**re: Site Servicing Plan Review**  
**Proposed Multi-Storey Buildings**  
**Greystone Village - Phase 3 - Scholastic Drive - Ottawa**

**file:** PG5383-MEMO.03 Revision 1

**PG5383-MEMO.03 - FIGURE 1 Revision 1**  
**SERVICES REQUIRING INSULATION**  
**FOR FROST PROTECTION**  
**June 6, 2022**

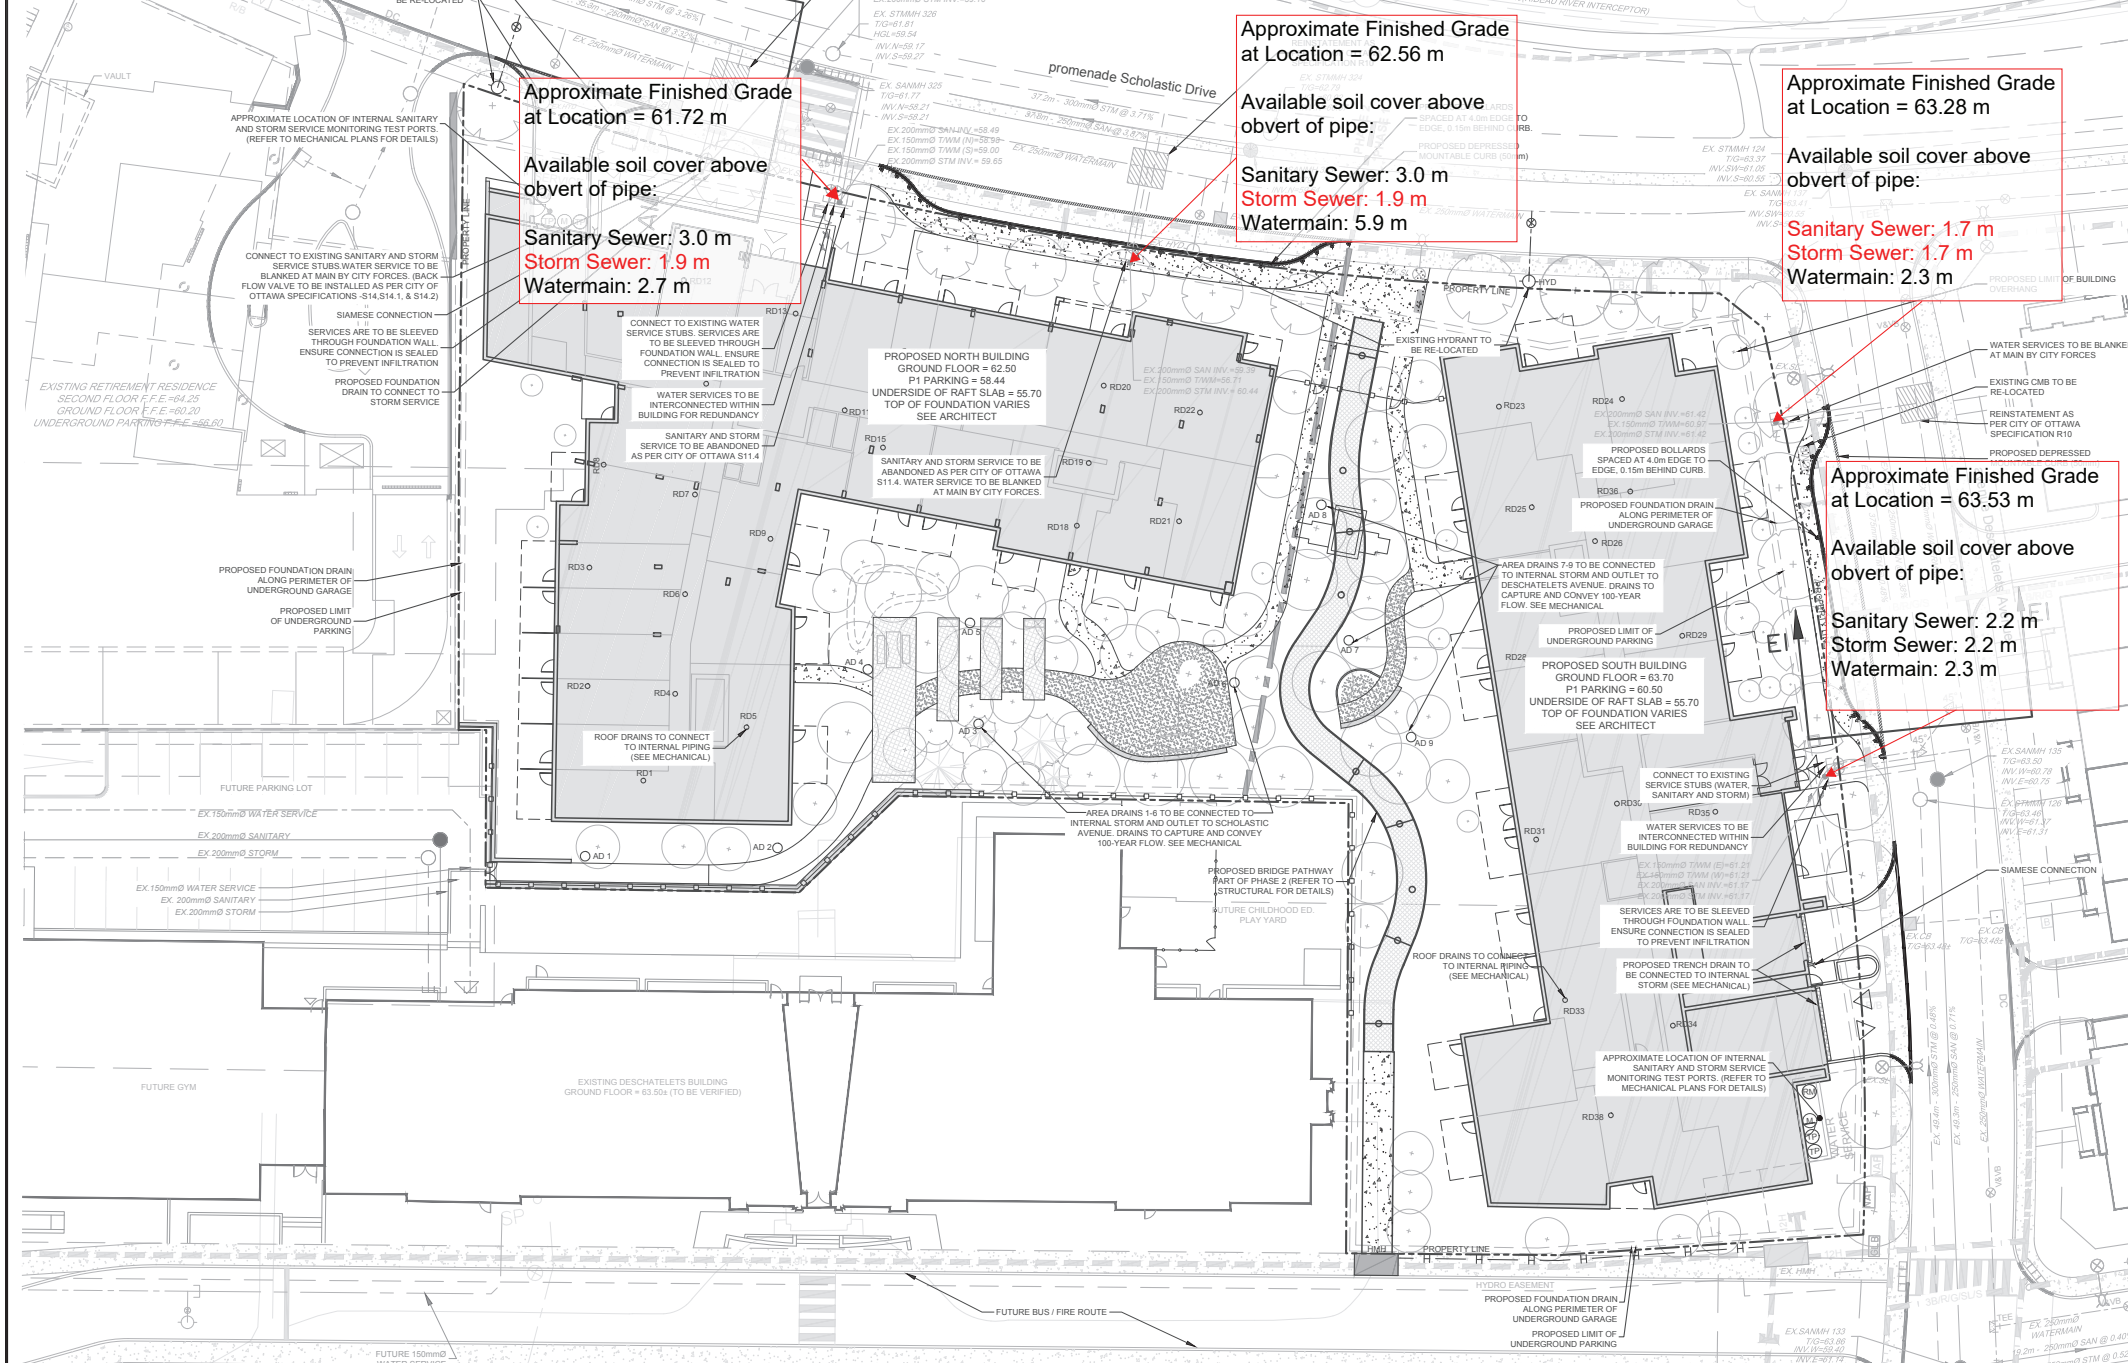
Based on our review of the site servicing plan, insufficient frost protection has been provided to sections of the storm and/or sanitary services which are noted to tie into the existing services located along Scholastic Drive and Deschatelets Avenue.

Specifically, the storm services located at the eastern portion of the site, tying into the services along Scholastic Drive, as well as the storm and sanitary services (invert elevation = 61.42 m) located within the southeast corner of the site and tying into the existing services along Deschatelets Avenue, will be founded within the frost zone (i.e. approximately 2.1 m below the finished grade). Refer to Figure 1, attached to the current memorandum, which illustrates these approximate locations. Frost protection of the site servicing is recommended where insufficient frost cover has been provided.

Any portion of the services installed at a depth of 2.1 m below finished grade or deeper is considered to have sufficient soil cover for frost protection. However, based on our review, the aforementioned sections of site servicing and their subgrades are anticipated to be founded within the frost zone. Where insufficient soil cover is present above the obvert of the pipe, the following frost protection criteria should be followed:

All rigid insulation should consist of either Dow Chemical High-Load 40 (HI-40), Styro Rail SR.P400, or equivalent approved by Paterson. The placement of all insulation within the service trenches must be reviewed and approved by Paterson personnel at the time of construction.
